**To: Sherborn Zoning Board of Appeals, ZBA**

**From: Sherborn Groundwater Protection Committee (GPC)**

**Subject: Revised GPC Comments for ZBA on the proposed 40B Farm Road Homes (approved by vote at GPC 9-13-23 meeting).**

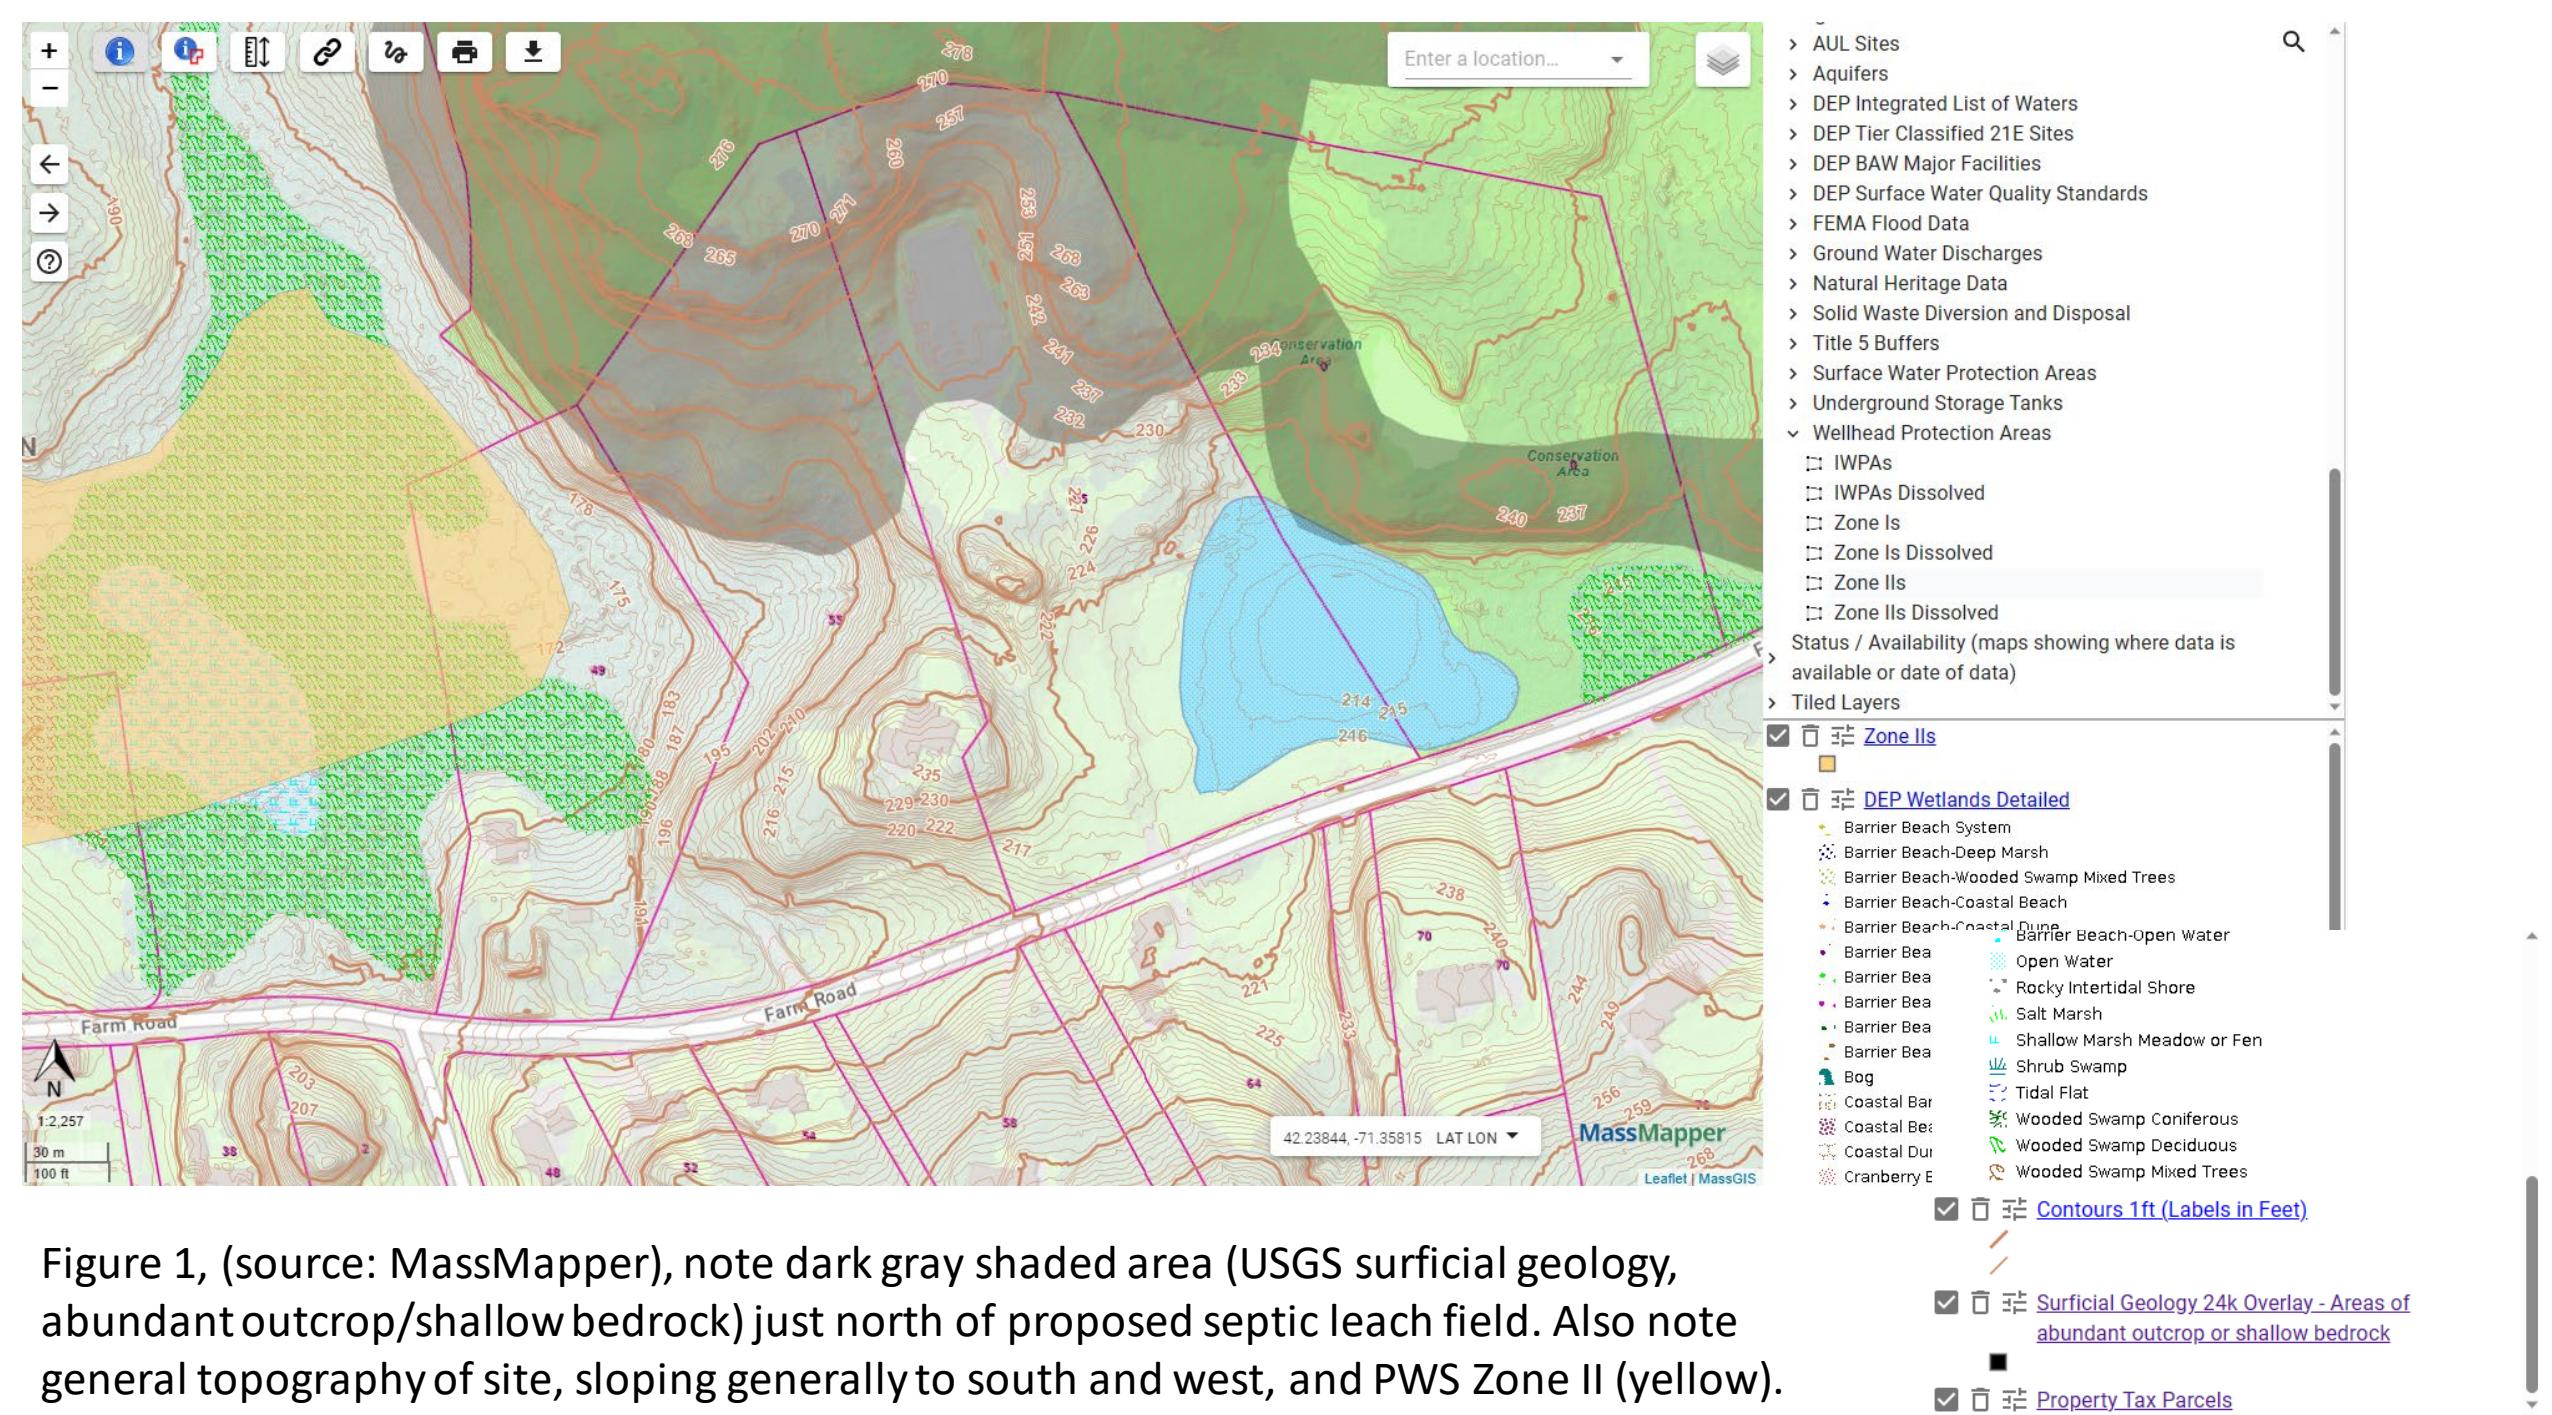
b. USGS Surficial Materials maps of this site area indicate a significant amount of bedrock outcrops, and shallow depth of overburden soils, including areas not far from the general location of the set of proposed two large septic leach fields located west of proposed house units # 11 – 18 (**Figure 1**, general area of proposed site, mapping source: MassGIS).

Given the amount of bedrock known to be present at this site, sufficiency of the overburden soil absorption areas and depth/volume of soils to treat adequately this large amount of septic effluent must be evaluated by an independent professional hired on behalf of the Town.

Infiltration of this large daily volume of wastewater onto the bedrock-controlled land could result in untreated water reaching nearby properties. Groundwater tends to flow preferentially along the soil overburden-bedrock interface. Untreated wastewater would also flow along this

interface in the direction of the slope of bedrock. Untreated septic waste could also enter bedrock fractures and flow to neighboring properties and wells. The topography of the land at the septic system shows a steep downward slope downward to the west/southwest, so properties to the west/southwest are downgradient of the septic system and could be impacted by it. Since the impacts of mounding and the direction of bedrock fractures is not known, locations in other directions may also be downgradient and impacted by the septic waste.

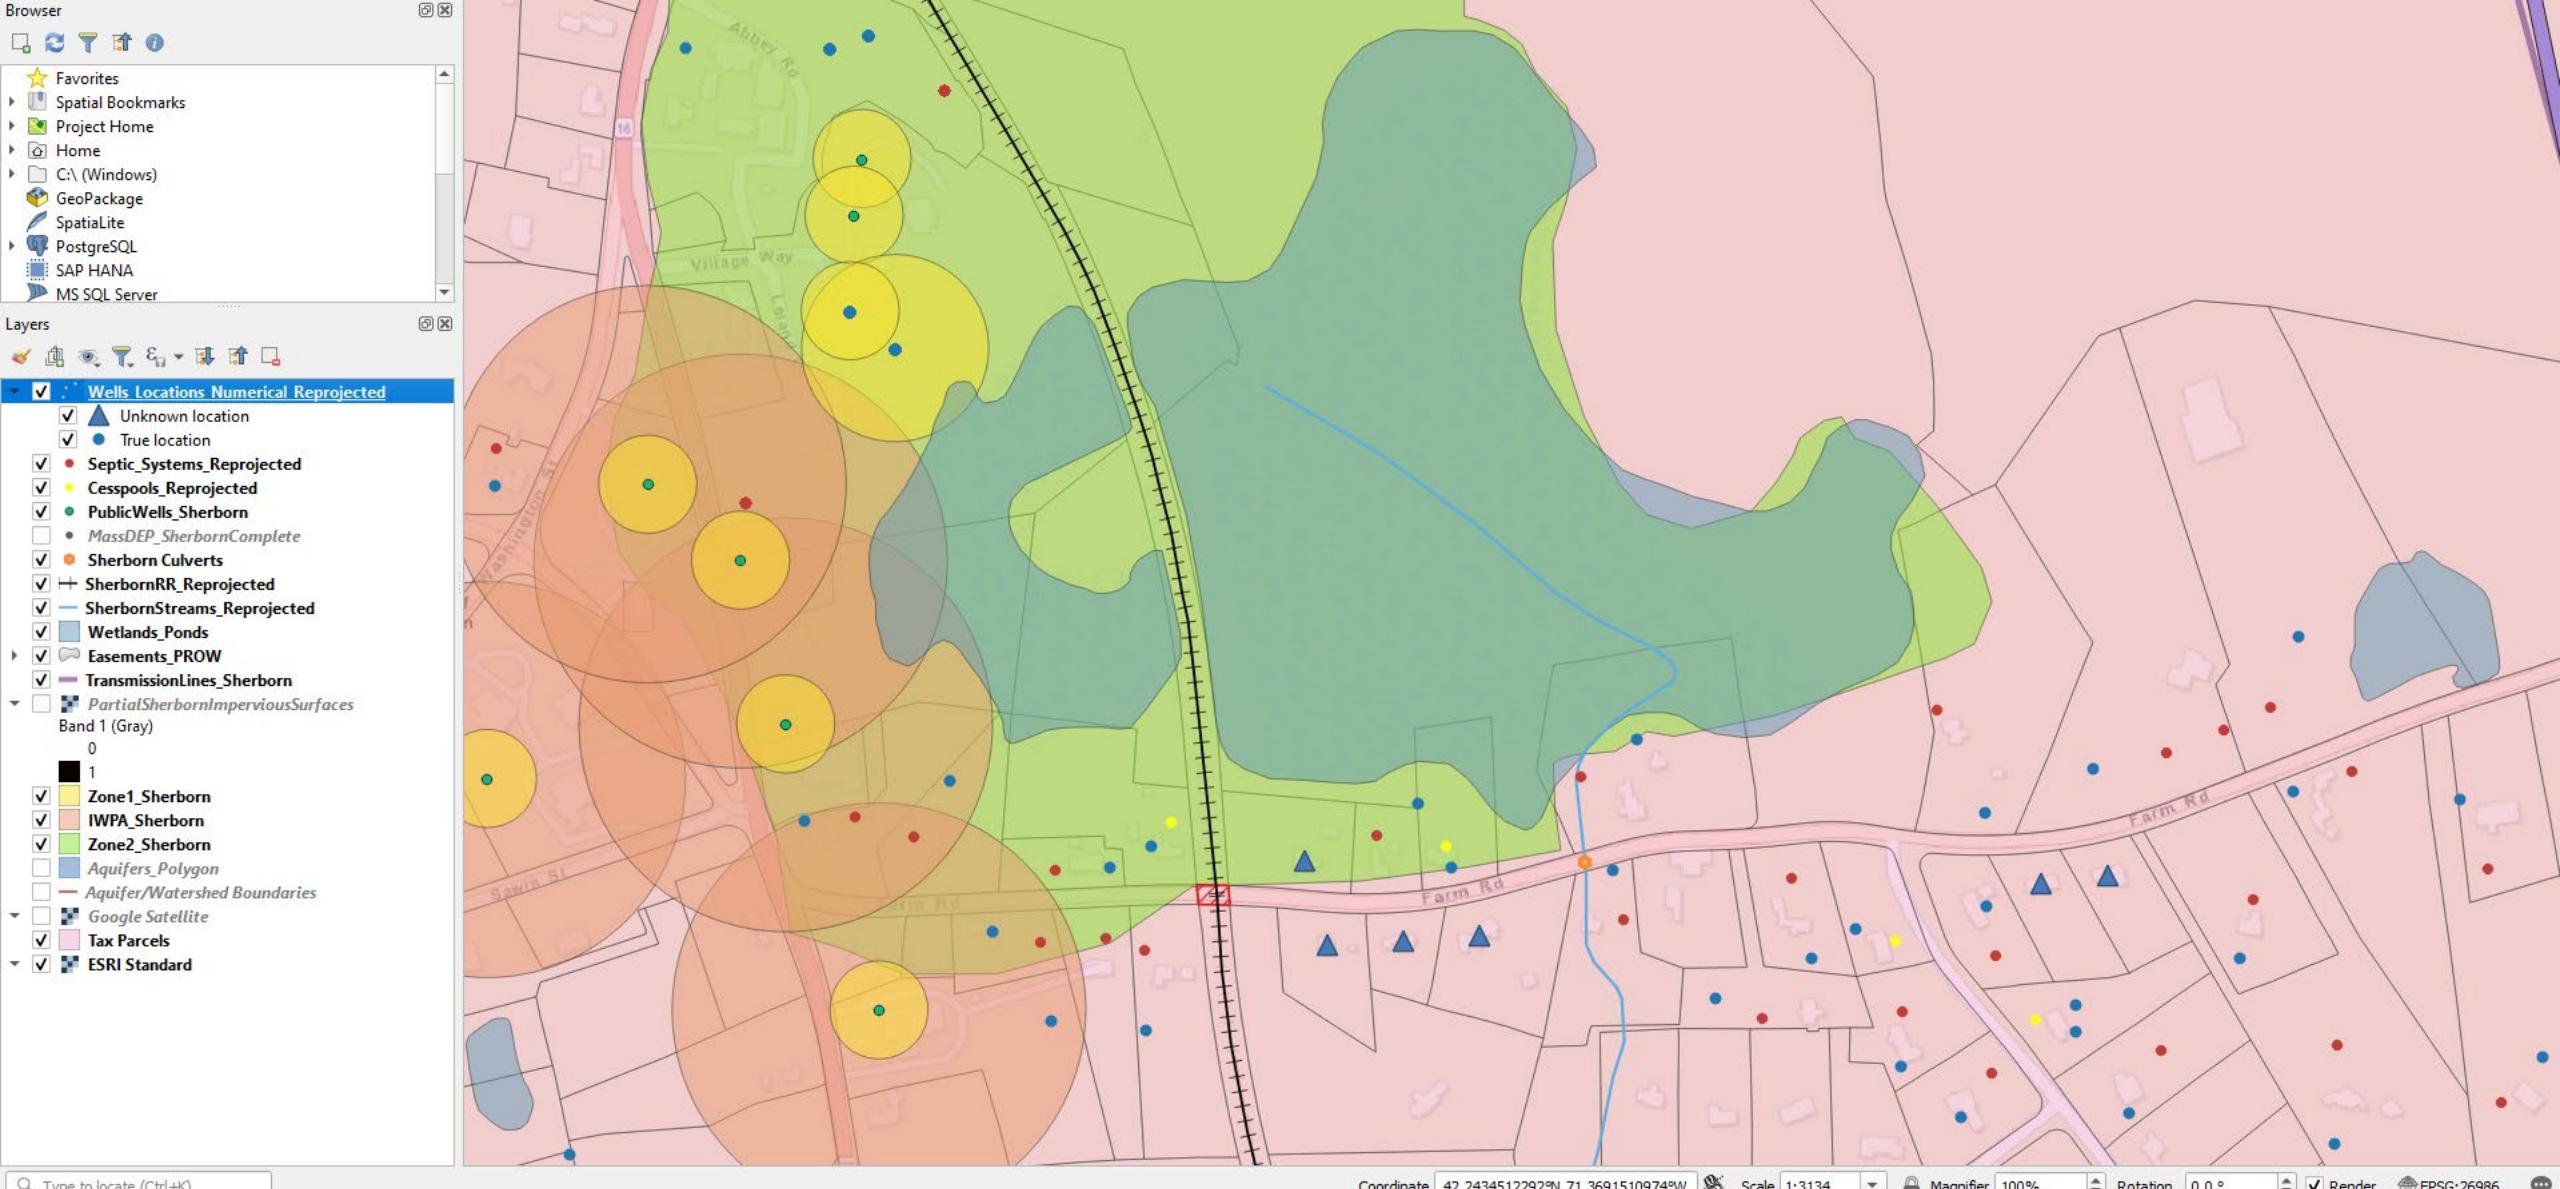
<https://www.sherbornma.org/sites/g/files/vyhlif1201/f/minutes/m22-0216.pdf>, video recording available). With this significantly larger 40B proposed project a more extensive nitrate study needs to be performed and new attention be paid to protect both the new 40B dwelling drinking water wells, the existing abutters wells, and the several PWS wells located west of the site, (Rt 16/27 area, **Figure 2**), and downgradient wetlands.

b. We have concerns that untreated or inadequately treated wastewater could infiltrate bedrock fractures, and rapidly travel to any new or existing bedrock drinking water wells on- or off-property, thus compromising drinking water quality (see **Figure 2**). Moreover, it can take years for problems to develop in deep bedrock wells, given the unknown flow patterns underground.

Figure 3. Proposed site plan (southeast section), above. Areal photo views, by year, from MassMapper, showing range in pond surface area along Farm Road.

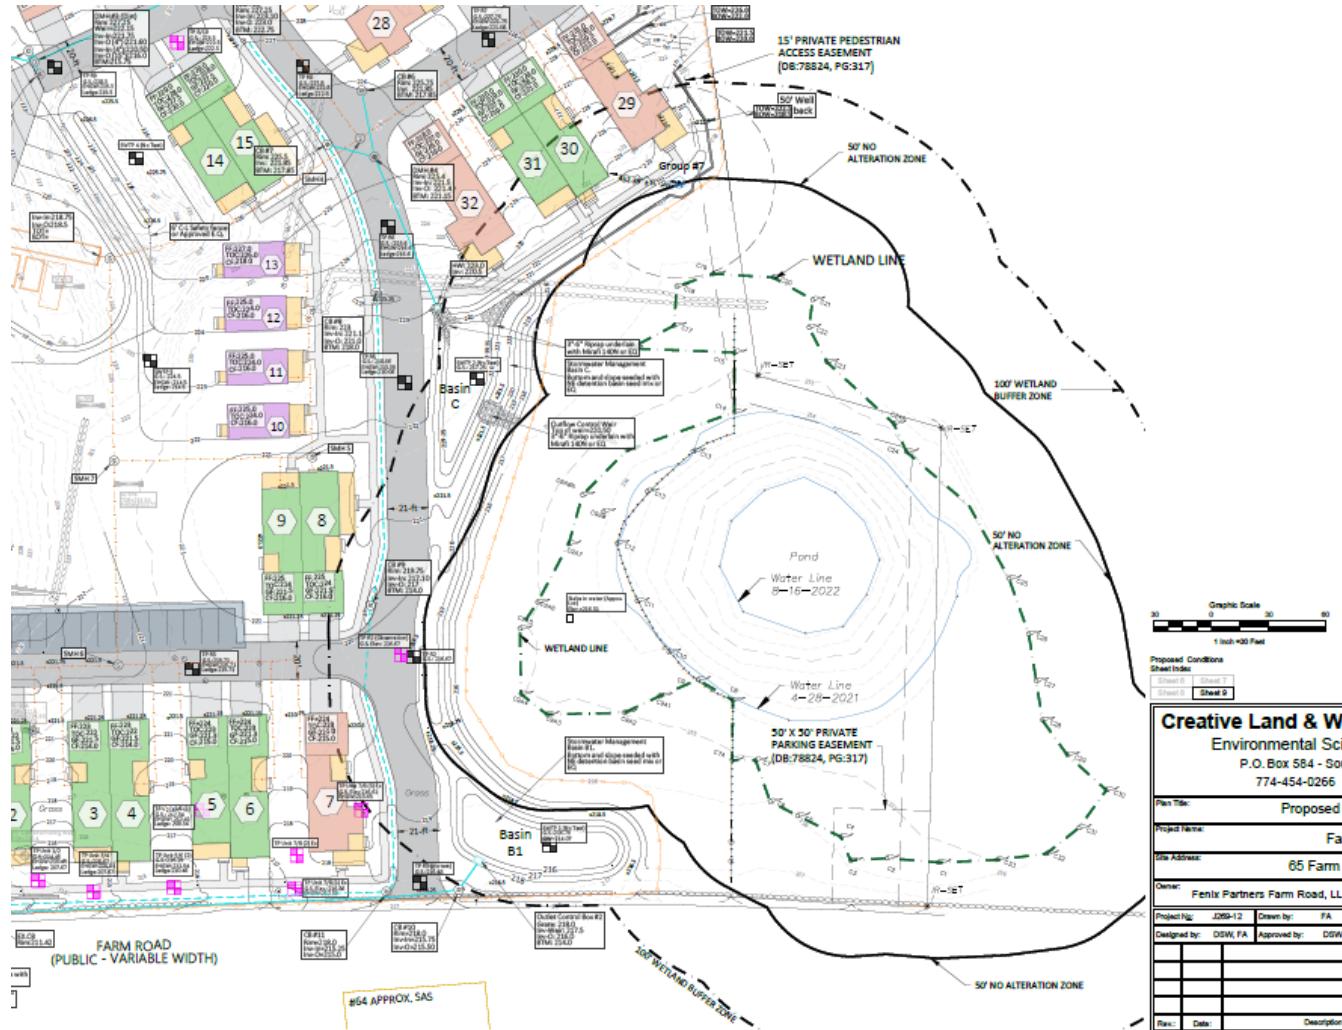
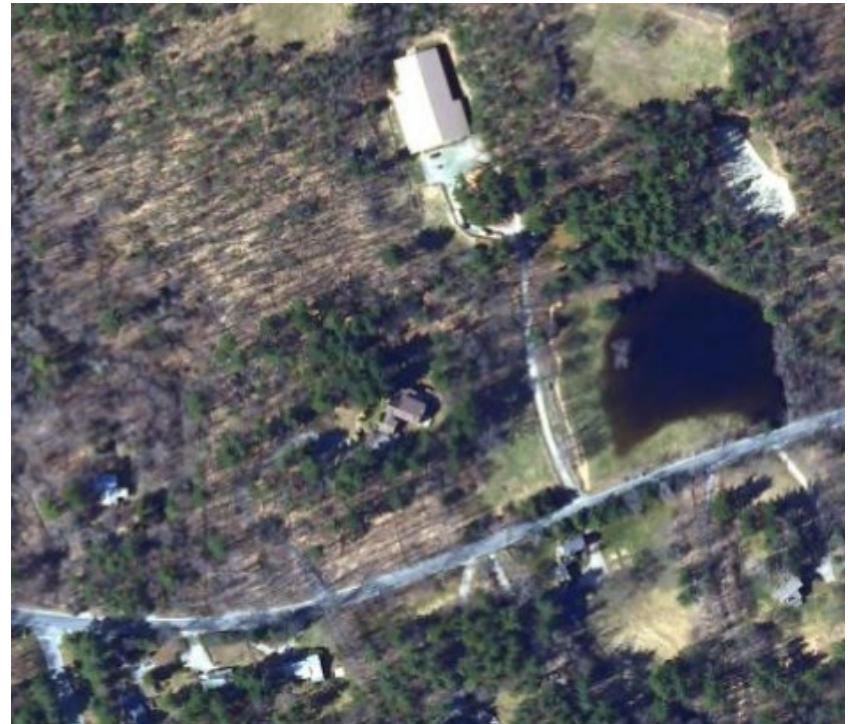
b. Another proposed stormwater basin is located downhill to the existing pond at the southeast end of the property. The pond already varies constantly in total size and depth based on average seasonal precipitation and groundwater levels (see **Figure 3**, with two examples of the change in pond size/area over the years). The new main entry road and potentially some housing units, as currently shown in the plan, may experience flooding, even with the proposed berm addition, if the pond expands significantly following a future storm event, and adding additional storm water to this area from the development's stormwater basin would worsen flood conditions. Future climate change trends will only exacerbate the extent of this flooding. A stormwater plan evaluation would need to account for the full drainage area tributary to the overall site and especially the existing pond.
